## **ALERT SERVICE BULLETIN**

**205B-23-74**

**SUBJECT:** TENSION ROD ASSEMBLY P/N 205-030-249-009 OR 205-030-249-013, INSPECTION OF.

**HELICOPTERS AFFECTED:** Serial numbers 30066, 30166, 30188 and 30297.

LOOKING OUTBOARD ON LOWER ATTACHMENT  
Figure 5. Rework requirements

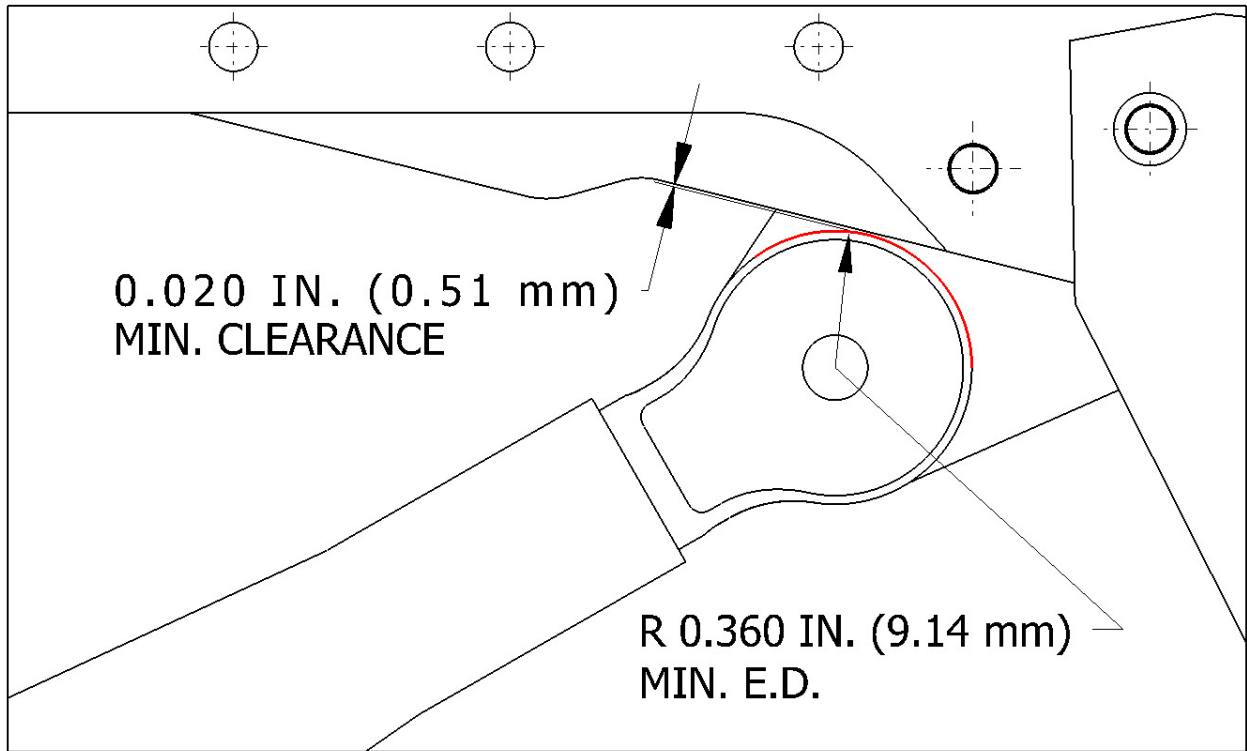
It is acceptable to remove material from the rod ends and/or the structure attachment fittings provided the inspection criteria defined in **PART I** are respected (Figures 4,5 and 6).

5. Trim and deburr previously marked material on the affected rod end and/or structure attachment fitting. Ensure the inspection criteria defined in **PART I** are respected (Figures 4,5 and 6).

Figure 1. Inspection requirements.

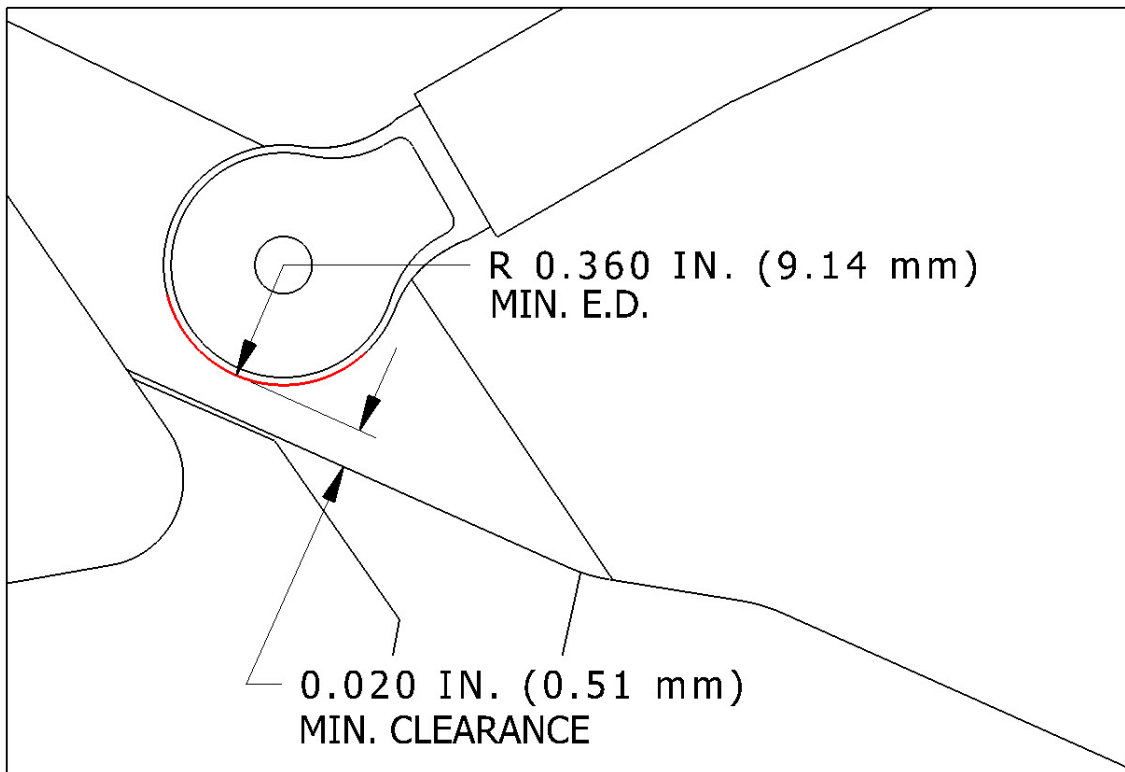
2. Inspect the forward end (upper attachment location) of the tension rod assembly as follows:
  - a. Inspect the outboard side of the tension rod assembly rod end for a possible over trimmed condition. Minimum acceptable radius dimension measured from the bolt hole center is 0.360 inch (9.14 mm) edge distance (E.D.) (Figure 1). Removal of the attachment bolt may be required to perform this measurement. Record findings.
  - b. Check for fouling or low clearance conditions between the rod end and the structure (cap, web, angle). Minimum acceptable clearance is 0.020 inch (0.51 mm) (Figure 1). Record findings.
3. Inspect the aft end (lower attachment location) of the tension rod assembly as follows:

Figure 2. Inspection requirements

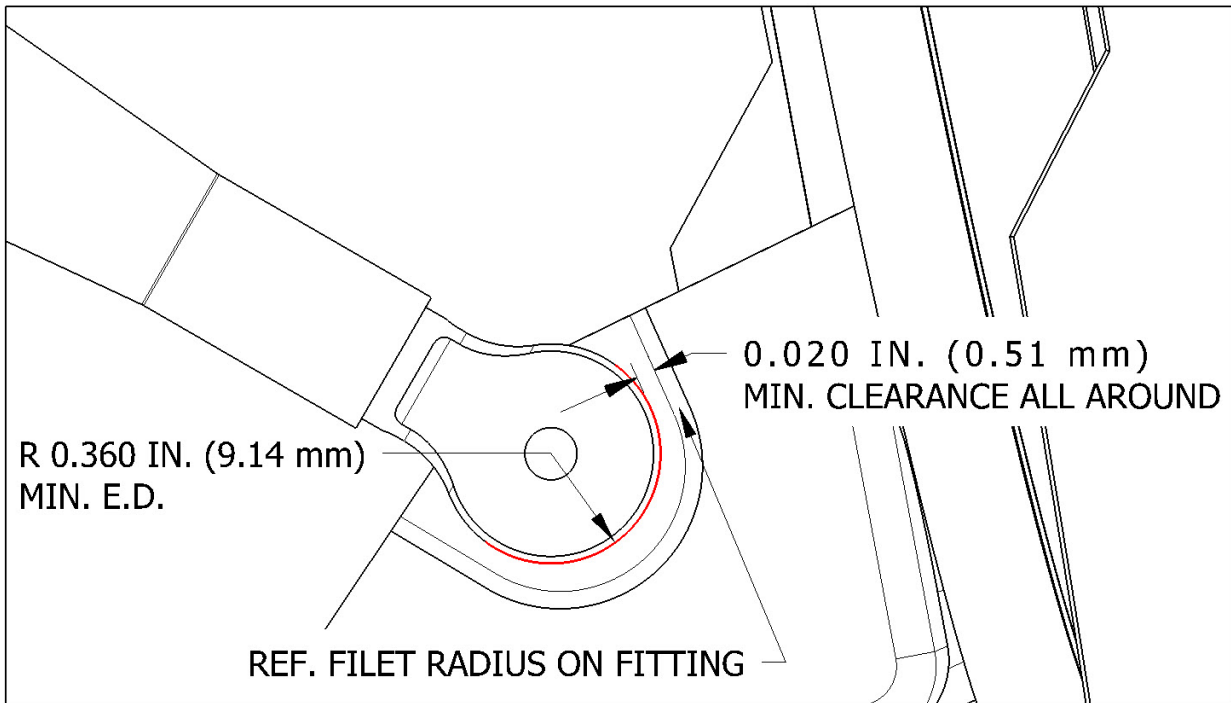
- a. Inspect both sides of the tension rod assembly rod end for a possible over trimmed condition. Minimum acceptable radius dimension measured from the bolt hole center is 0.360 inch (9.14 mm) edge distance (E.D.) (Figure 2 and 3). Removal of the attachment bolt may be required to perform this measurement. Record findings.

- b. Check for fouling or low clearance conditions between the rod end and the structure (cap, web) on the outboard side and the fillet radius on the inboard side of the fitting. Minimum acceptable clearance is 0.020 inch (0.51 mm) (Figures 2 and 3). Record findings.

Figure 6. Rework requirements

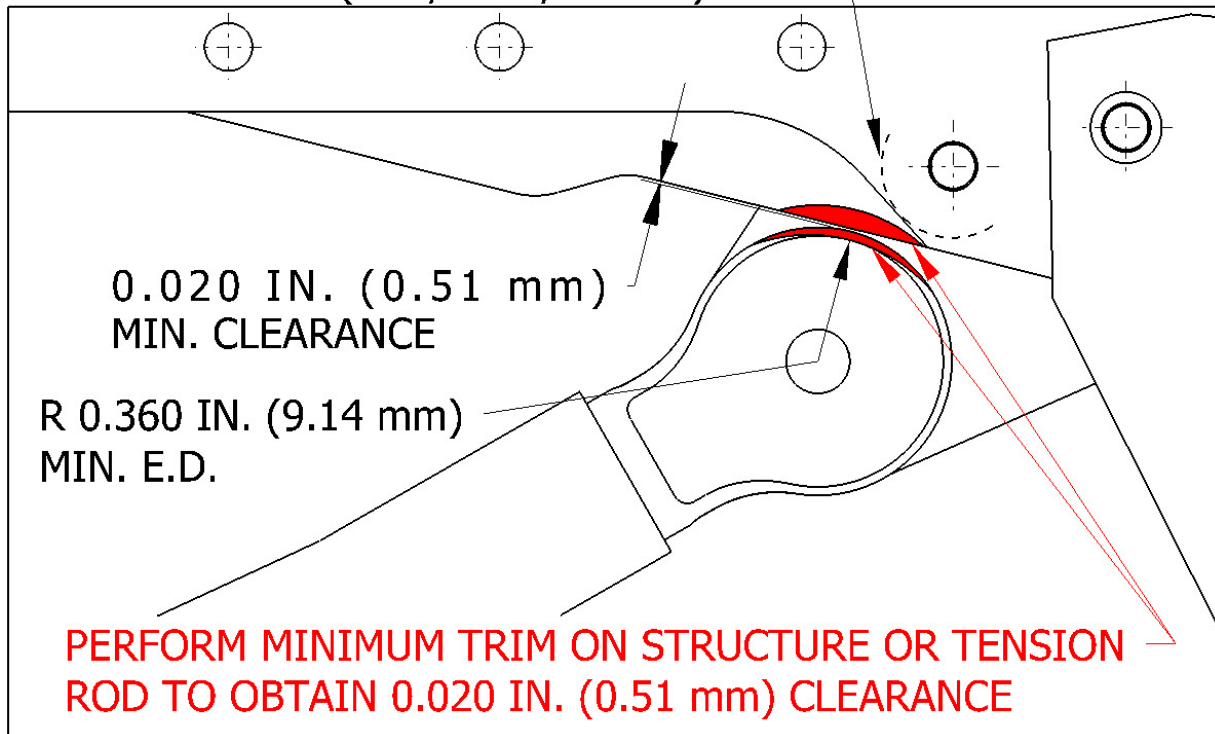
KEEP 0.280 IN. (7.11 mm) MIN. E.D.  
FOR FASTENERS (CAP, WEB, ANGLE)

Figure 7. Tension rod assembly proper installation verification.

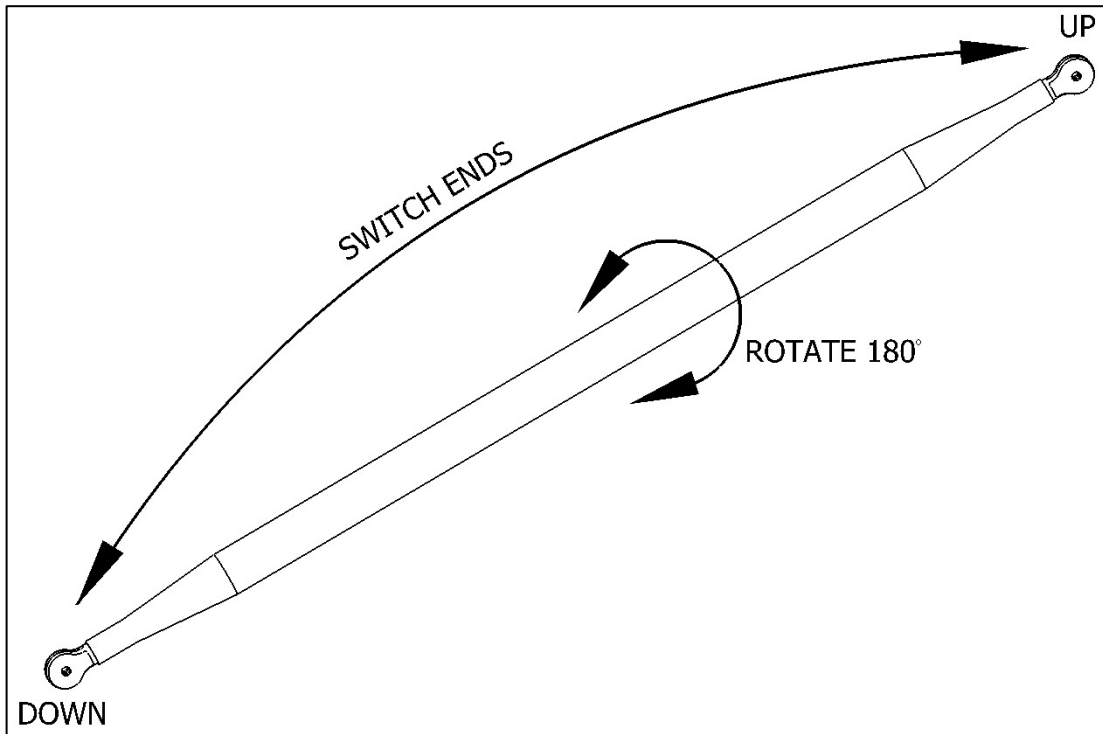
1. If a fouling or a low clearance condition exists, the tension rod assembly may have been incorrectly installed. Prior to trimming the rod ends, remove the tension rod assembly (step 1.a.) and try different orientations by rotating and/or switching ends to obtain the best possible fit (Figure 7). If proper clearance dimensions as defined in **PART I** cannot be met, proceed with step 3.
  - a. Removal of tension rod assembly:
    - (1) Remove the nut, bolt, and washers from the aft end of the tension rod assembly.
    - (2) Remove the nut, bolt, washers, and tension rod assembly from the bulkhead attachment point.
